City of Plymouth Planning Commission

Regular Meeting Agenda

SP23-04: 885 Starkweather
Special Land Use and Site Plan Review
Zoned: B-1, Local Business District
Applicant: Don Soenen

**Special Land Use and
Site Plan Review
For
Plymouth, Michigan**

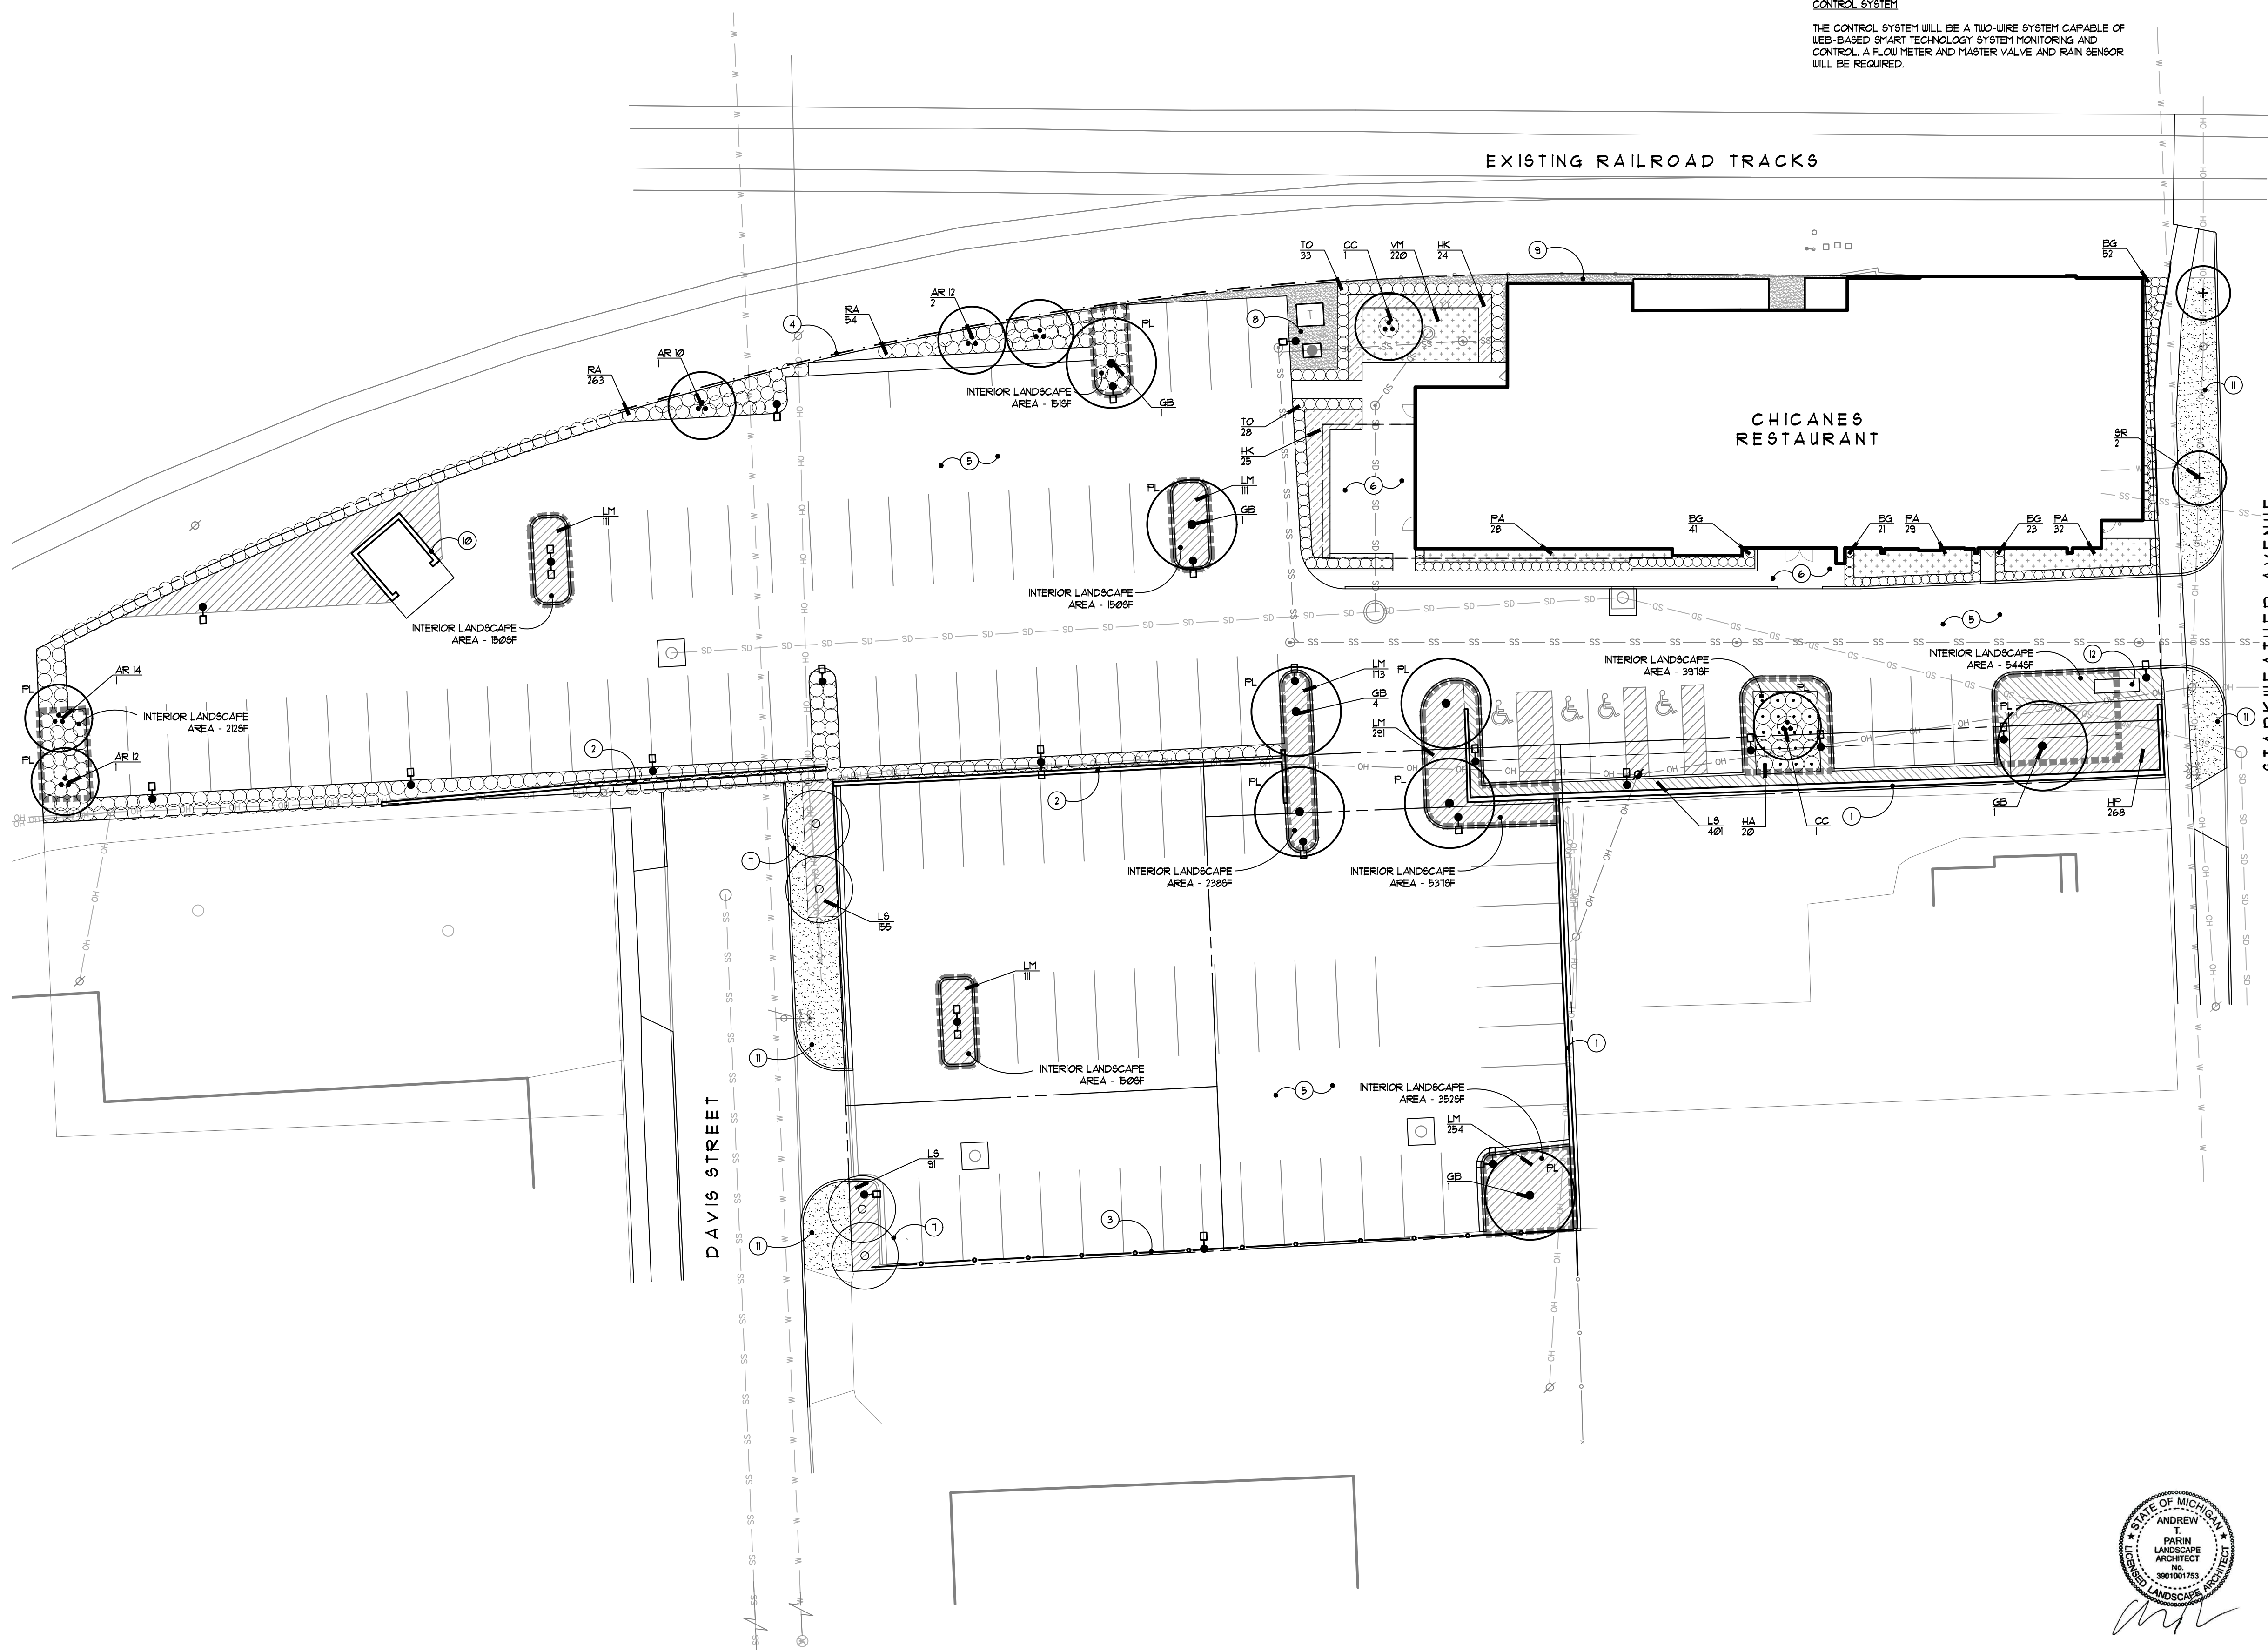
Landscaping. Sec. 78-351 calls for landscape buffer strips between the right-of-way and a parking lot, as well as parking lot landscaping. Sheet L-1, *Landscape Plan*, of the proposal shows the following:

1. Two (2) street trees along Starkweather St., and four (4) existing Japanese maple street trees along Davis St. The ordinance requires two additional trees along Starkweather St. (or 1 tree/30 lineal feet of frontage). This frontage has overhead powerlines that will conflict with a large shade tree; however, two more ornamental trees could be used to provide a small amount of shade and buffering along this frontage.

The ordinance also requires five (5) shrubs for every 30 lineal feet of frontage. The Starkweather frontage shows the required number of shrubs; however, no shrubs are shown along the Davis St. frontage. Eighteen (18) shrubs need to be added along this frontage.

2. 2,881 s.f. of interior parking lot landscaping is proposed. The plans do not provide an area calculation for “existing parking lot pavement,” so we can’t confirm that the interior landscaping meets this requirement (or 1 s.f. of landscaping for every 15 s.f. of parking lot). The area of the parking lots needs to be provided. The size of the proposed islands meets the minimum area requirement, and they are appropriately arranged to break up the expanse of pavement and direct vehicles. The number of parking lot trees meets ordinance requirements (or 1 tree/300 s.f. of interior parking lot landscaping).

Items to be Addressed: 1. Add two (2) ornamental trees along Starkweather St. frontage. 2. Add 18 shrubs along Davis St. frontage to screen parking lot from road. 3. Provide an area calculation of the parking lot pavement on the plans. 4. Shift parking lot island to east, and plant entire area with shrubs to create 60-80% opacity, and screen neighbor to the south. 5. Paint entire retaining wall (all sides). 6. Modify Note 14 on Sheet C-1 to excavate new planting beds that had been paved to a minimum of 1-foot deep, and refill with appropriate planting medium. 7. Confirm parking lot islands will be irrigated. 8. Lighting.

PLAN NORTH
1
A101
PROPOSED FLOOR PLAN
1/8" = 1'-0"

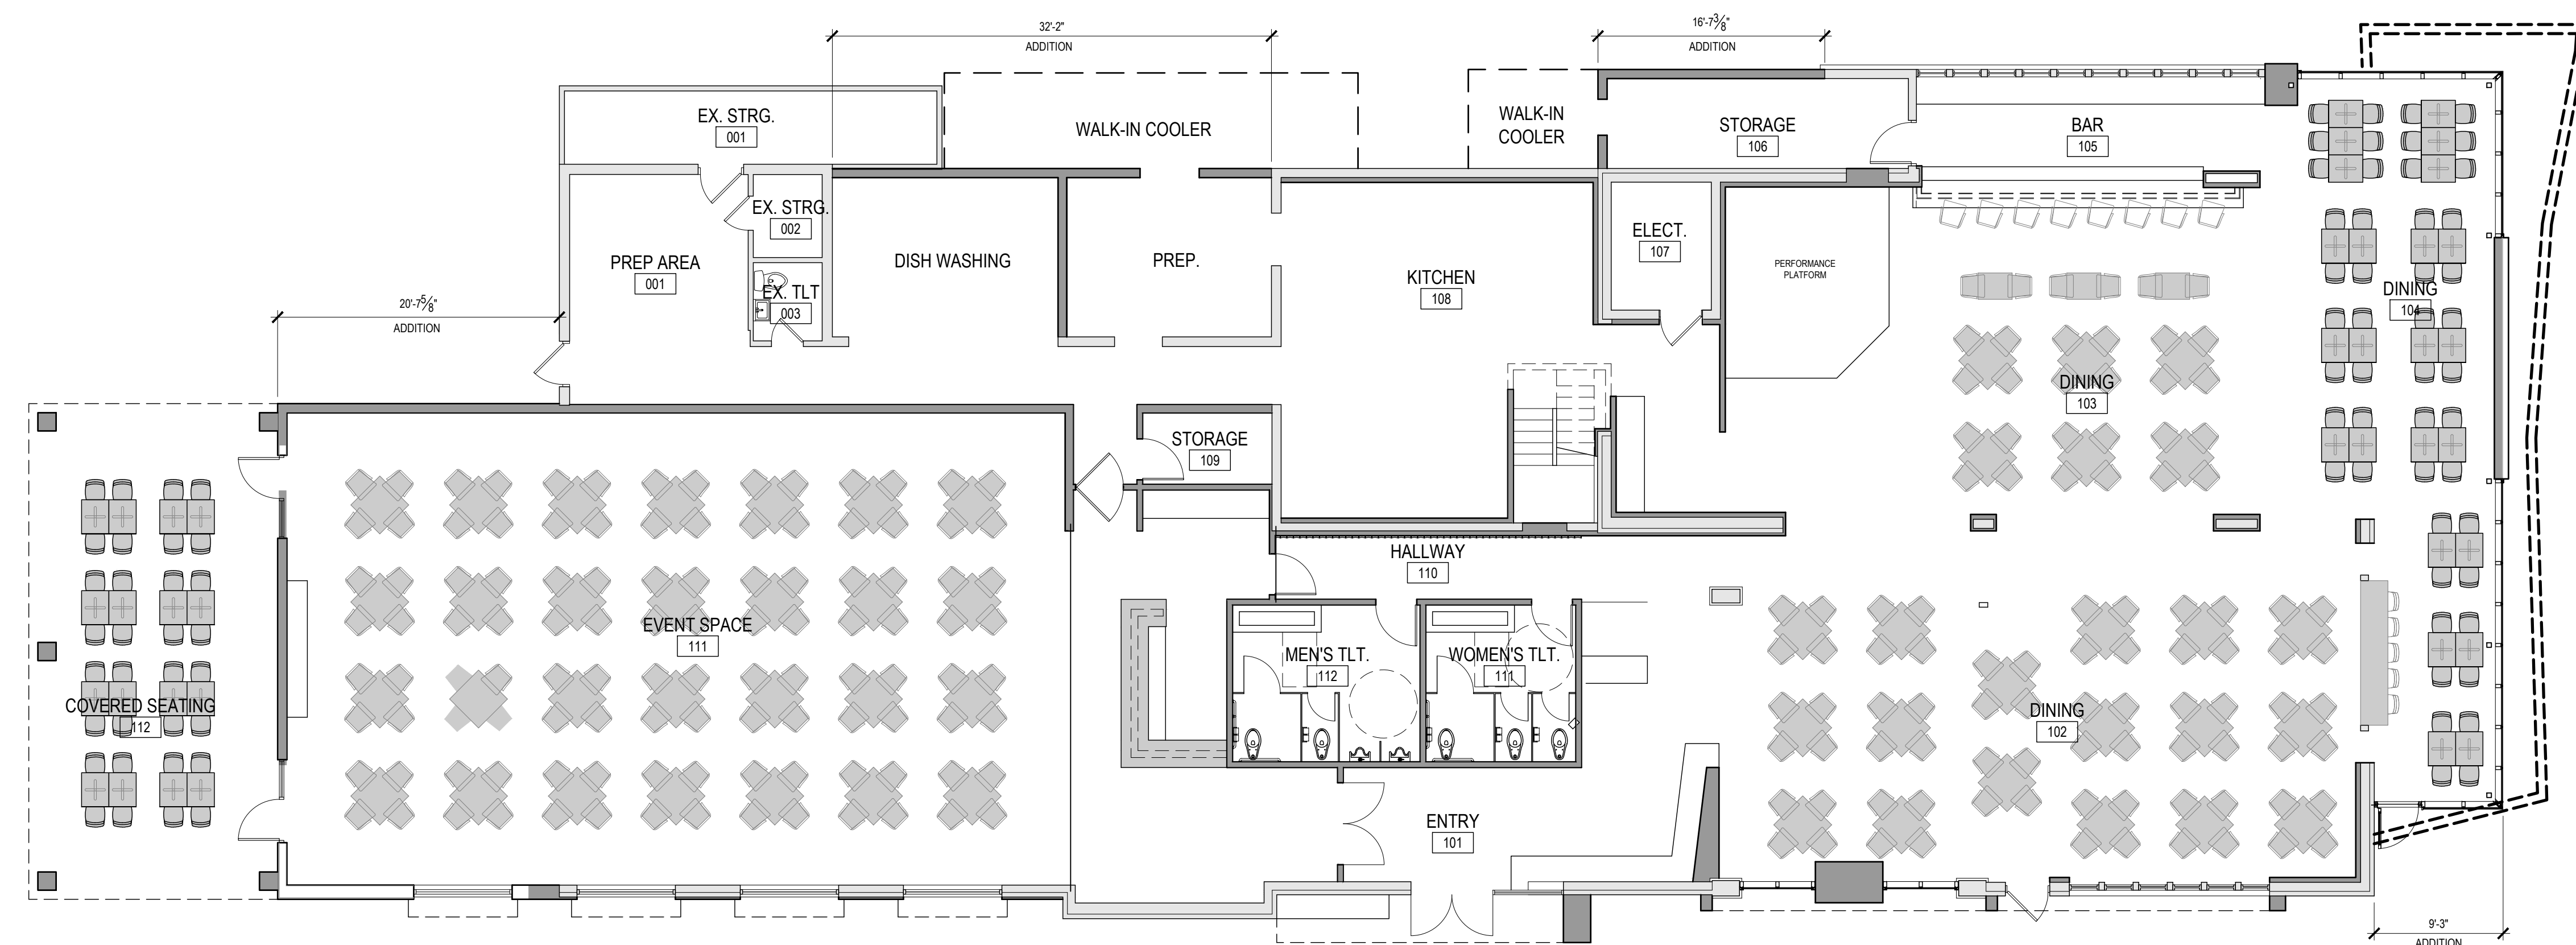
- 1. No more than ten seats shall be allowed at the bar.** *CWA Comment: Sheet A101 shows a floor plan, and indicates the bar will have 8 seats.*
- 2. Alcohol shall be served only to seated patrons or persons standing in the designated standing area as outlined in subsection 78-102(2)(c).** *CWA Comment: Given the close proximity of seated tables near the bar, there is no "designated" standing area for patrons using the bar.*

- 3. The standing area adjacent to the bar shall not exceed 150 square feet.** *CWA Comment: Again, the arrangement of the seated tables near the bar does not offer any standing area.*
